SSM's external experts' reviews of
SKB's safety assessment SR-PSU –
radionuclide transport, dose assessment,
and safety analysis methodology
Initial review phase

SSM's external experts' reviews of
SKB's safety assessment SR-PSU –
radionuclide transport, dose assessment,
and safety analysis methodology

Date: March 2016

Review of radionuclide transport methodology in SR- PSU

Figure 2-1. Arithmetic mean of the annual effective dose to the most exposed group for releases from the Silo in the global warming calculation case (CCM_GW). (Figure 5-6 of the Radionuclide Transport Report).

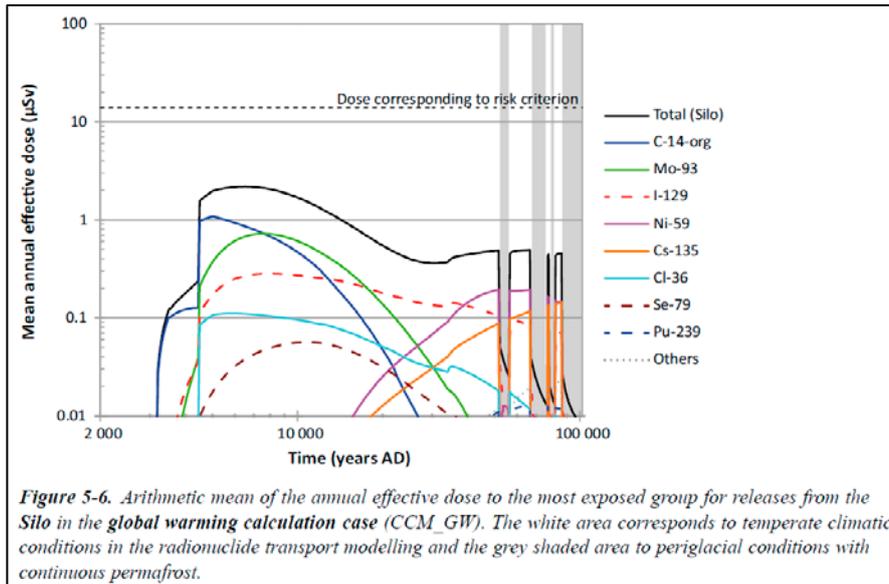
Deterministic calculations are rarely presented (Figure 5-11 in the Radionuclide Transport Report is a singular exception for the main scenarios) and seem only to be used when the probabilistic approach is infeasible. In a small number of cases, the 5th and 95th percentiles of the calculated doses are presented (again Figure 5-11 of the Radionuclide Transport Report is an example).

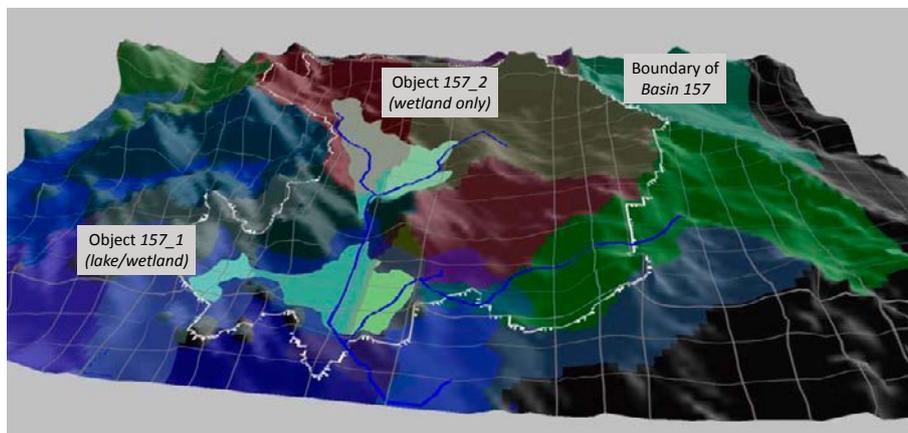
One thing that is clear is that discharges to local topographic minima (depressions) in the basin are not the only geosphere-biosphere interface of concern. The biosphere object with the highest density of release points is designated Object 157_2 by SKB and is found at a higher elevation in the basin (see Figure 1).

Figure 2: Illustration of the published output from MIKE-SHE. Results for 5000 CE.

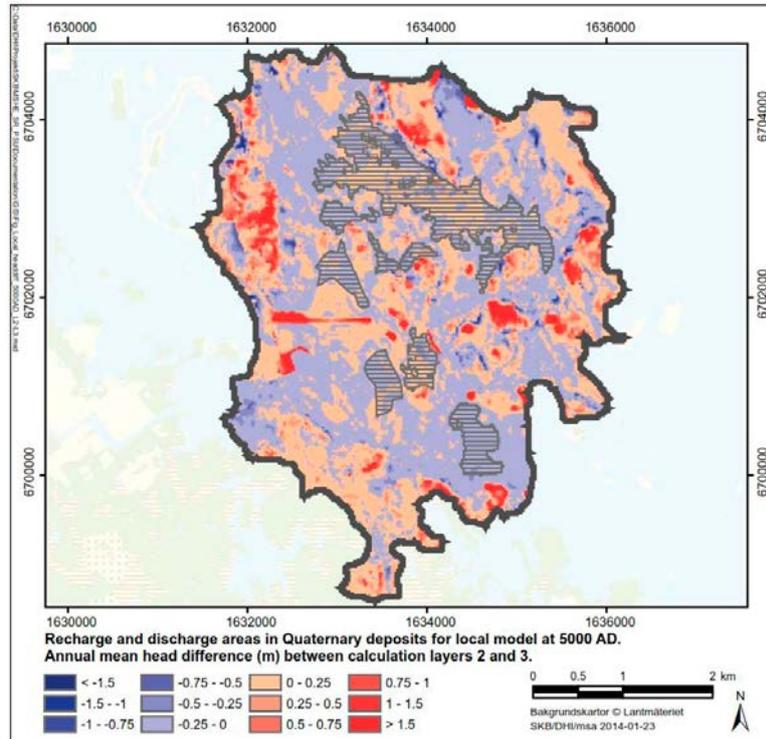
Figure 4-7 from the Synthesis Document (reproduced here as Figure 2) shows the recharge/discharge areas in the MIKE-SHE modelling at 5000 CE. To get an adequate understanding of the hydrological modelling a request should be made for the data on which this map (and the situation at 3000 CE and 11000 CE) is based – both as mapping files **and** as the numerical data from the MIKE-SHE model itself. Derivation of the numerical fluxes (shown in Figure 3) would then be possible **in principle**. It seems that this is done by a subroutine within MIKE-SHE. The details should be presented since it seems likely that they are contingent on where the boundaries of the object are placed. Again interface with SKB would probably be needed to expedite this RFI.

MIKE-SHE modelling also has an impact on the choice of biosphere objects – see Figure 2 above, where the recharge/discharge areas can also be used to identify object boundaries. Definition of the object delineations has a potentially important role to play in the dose assessment since too large an object can result in unwarranted spatial dilution of the release. The procedure for the object boundaries from the surface hydrology (Werner *et al.*, 2013), the deep geology and particle tracking (Odén, 2014) and topographic maps (Strömgren & Brydsten, 2013) is not fully revealed in the documentation reviewed so far and therefore is an area that requires deeper review. As part of the review it would be useful to have access to the object-defining characteristics in GIS-format files so that the reviewers would be able to interrogate maps for themselves. These data should be requested from SKB. These details will be of use in any alternate modelling that SSM should require as part of the main phase review.

Figure 3: Extracted hydrological details for object 157_2 at 5000 CE as used in the DAM. How is the information in Figure 2 translated into these values. Details are needed.

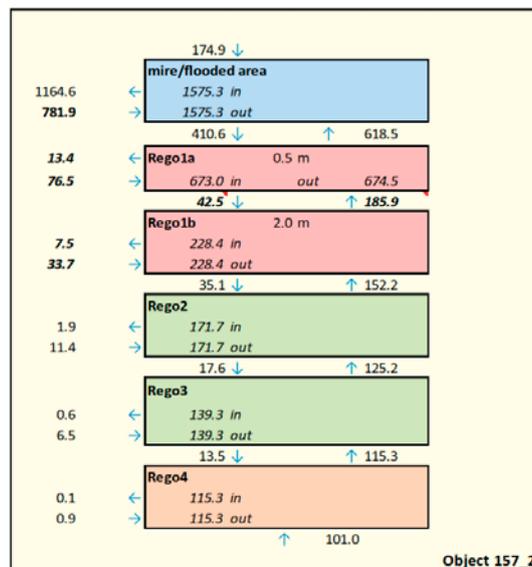
Appendix 1 of Werner *et al.* therefore needs to be reviewed in some detail. There are the familiar “Christmas Tree” plots, as used in SR-Site. These appear to give overall water balance for the landscape at different times and so are not necessarily useful in describing the individual biosphere objects. Their role and interpretation in relation to the information in Figure 2 and Figure 3 here need to be explained by SKB.

3. **Derivation of object water fluxes from MIKE-SHE modelling**. Comparing the details in Figure 2 and 3 in the report, SKB should illustrate how the SKB results for the landscape (illustrated by Figure 2) are converted into the detailed inter-compartment numerical values quoted in Figure 3. Because the water balance for each object will be contingent on where the object boundaries are placed, results should be provided for the whole of Object 157_2 as well as the subareas featured in the assessment of alternative object delineations reported in Section 10.8 of the synthesis document. At the same time SKB should explain the origin of the numbers in the “Christmas tree plots (eg, Appendix 1 of Werner *et al.*, 2013, Figure A1-1, etc.) as well as how they are used in the assessment. (Pages 14, 16.)

2. **Derivation of object specific flow systems at 3000, 5000 and 11000 CE.** Review of how information in Figure 2 is used to produce the numerical flux values in Figure 3. (Page 14, 16.)

Figure 4: Releases locations by particle tracking in hydrologic basins at two future times.

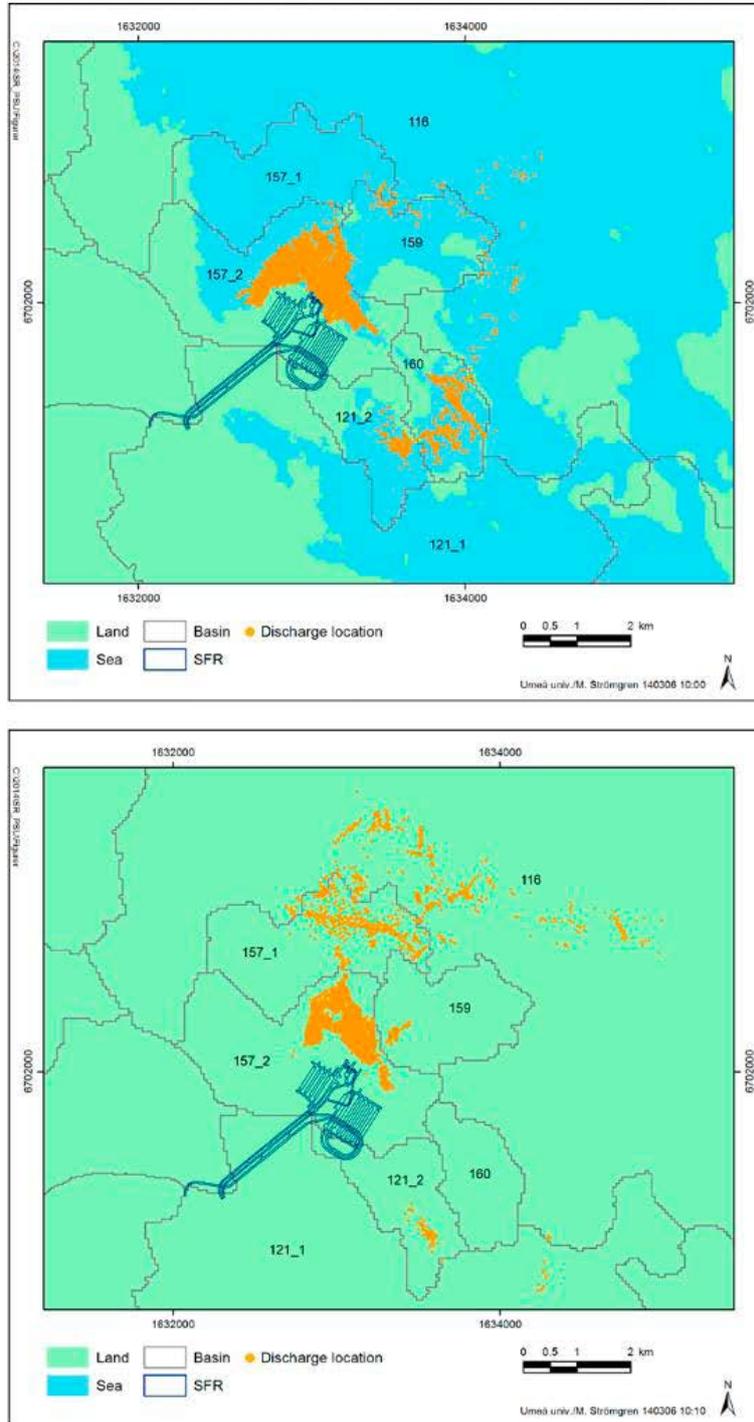
Overall, the procedure by which the boundaries are determined is not explicit in the documentation so far reviewed. There is evidently a requirement to combine information from a number of different sources, surface hydrology, release distribution and topography but how the procedure is carried out is well hidden. Figure 6-10 of the Synthesis document (reproduced here as Figure 4) provide some indication of how object boundaries might be identified. Clarification is required.

5. **Release point locations**, see page 18, above. The “exit point” locations as plotted in Figure 4-12 on page 50 of R-13-25 (Odén *et al.*, 2014). GIS format files giving release locations at a range of time points.

Figure 3: Locations of discharging particles from SFR at 9000 AD (Figure 6-12 from the Biosphere Synthesis Report). Basins are marked (grey outlines) and numbered, as is the explicitly modelled area of biosphere object 157_2 (black border).

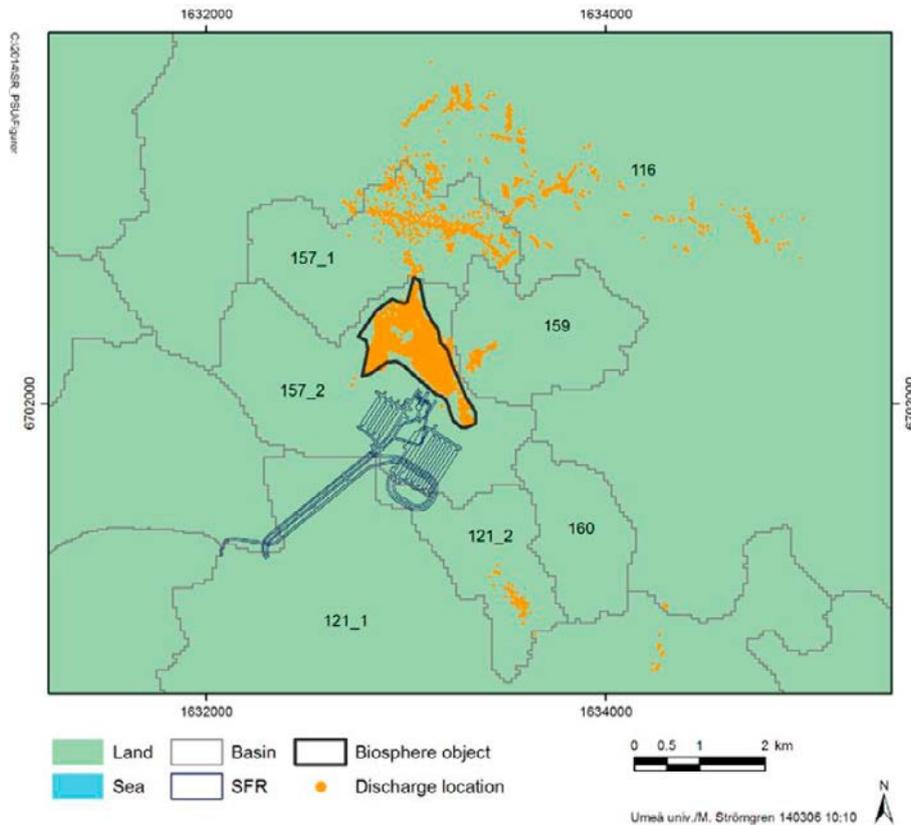
Given the above, it is not clear why SKB assign all releases to biosphere object 157_2 on its own in SR-PSU. Modelling of a case where releases were distributed resulted in a marginal increase in biosphere dose factors (see Section 3.2.7); that increase is observed even though less than 10% of the releases are distributed to objects other than 157_2⁹.

Figure 6: Modelled present-day landscape (a) compared to the actual present-day landscape (b), with examples of the lakes not predicted by the modelling highlighted in red (based on Figure 5-11 of the Biosphere Synthesis Report).

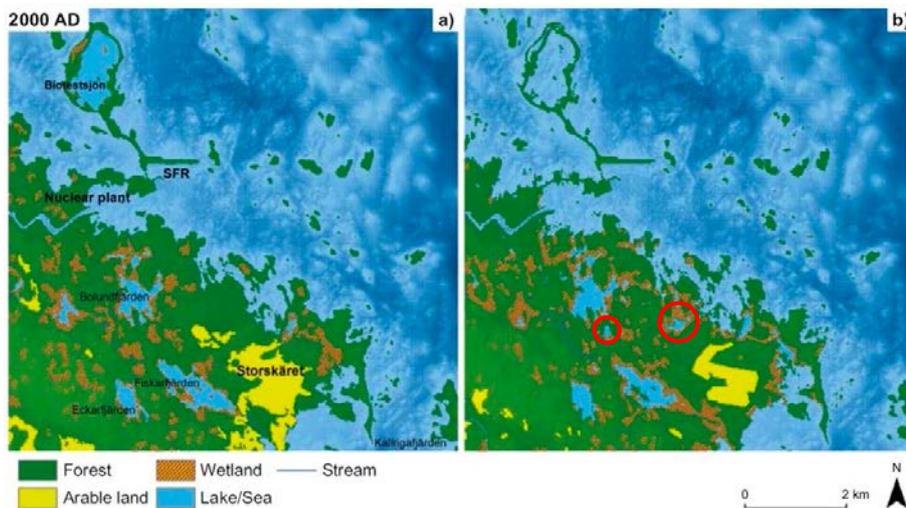
Uncertainties in the landscape modelling are exemplified by a comparison of a modelled reconstruction of the present-day landscape at Forsmark with the actual present-day landscape (Figure 6). The comparison shows a reasonably good reproduction of the landscape, although this is not necessarily surprising as the modelling has been calibrated to the present-day landscape (Brydsten and Strömberg, 2013). Notably, there are lakes in the present-day landscape that are not predicted in the landscape modelling (highlighted in Figure 6). These are explained in the Biosphere Synthesis Report as being ‘small lakes’ that are missing as a result of an assumption within the landscape modelling that small lakes are instantaneously filled-in. However, the approximate areas of the two lakes highlighted are 4.3 ha and 2.3 ha and are larger than some of the modelled lakes, so this does not satisfactorily explain the discrepancy.

4. Provide landscape modelling results at a scale that is more appropriate to the SFR assessment.
5. Provide an explanation for why the present-day lakes highlighted in Figure 6 are over-looked in the landscape modelling reproduction of the present-day landscape.

Figure 15: Potential settlement areas used as locations for drilled wells (Figure 6-10 from Werner et al., 2013).

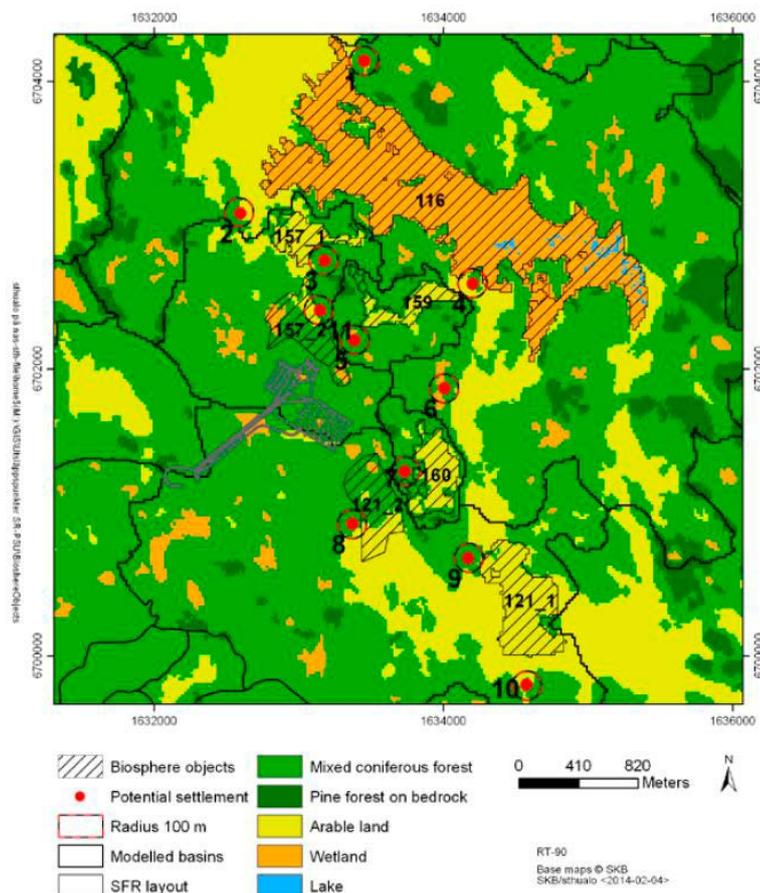
Discussion in Werner et al. (2013) notes that 80-90% of wells are located within 100-200 m of arable land. A circle of radius c. 200 m from arable land is shown in Figure 16, which highlights that there is notable overlap with the well interaction area. Although difficult to interpret from the figures in Werner et al. (2013), the modelled capture fractions for wells within the approximate region highlighted in Figure 16 is up to 17%⁵⁵. It would seem equally reasonable for wells to be located in this region as in the region used to justify a capture fraction of 0.3% in the main scenario (note also that there is no requirement for the well for a garden plot group to be within a biosphere object).

Figure 17: Maximum 'best estimate' biosphere dose factors from SR-PSU compared with those from SR-Site and SAR-08 (based on Figure 10-1 of the Biosphere Synthesis Report).

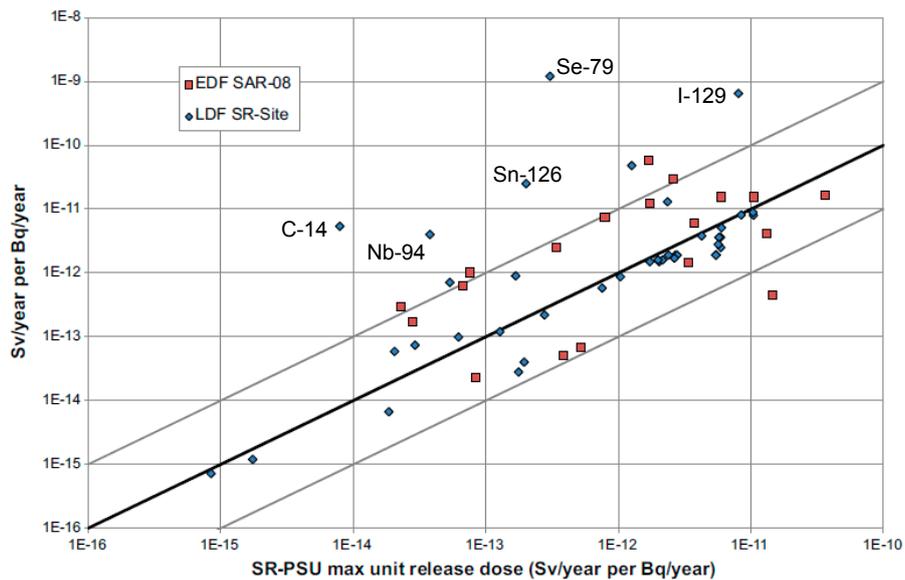
Comparison with SR-Site is considered here as the most interesting, because both assessments explicitly represent environmental change (unlike SAR-08) and because most of the dose factors relate to radionuclide releases to similar biosphere objects (i.e., small objects that lack a lake stage). Figure 17 highlights that dose factors for several radionuclide of typical importance to disposal of radioactive wastes have reduced by more than an order of magnitude (and up to over three orders of magnitude in the case of Se-79) since the SR-Site assessment was submitted in 2010. The differences are mainly attributed to greater use of site-specific information in parameterising the biosphere for SR-PSU. In particular, these concern sorption coefficients in the till (Se-79, Nb-94, Sn-126) and soil-to-plant concentration ratios (Se-79 and I-129). The very significant difference attributed to the use of more site-specific data highlights the approach to data for key radionuclides as being a topic that merits consideration for further review.
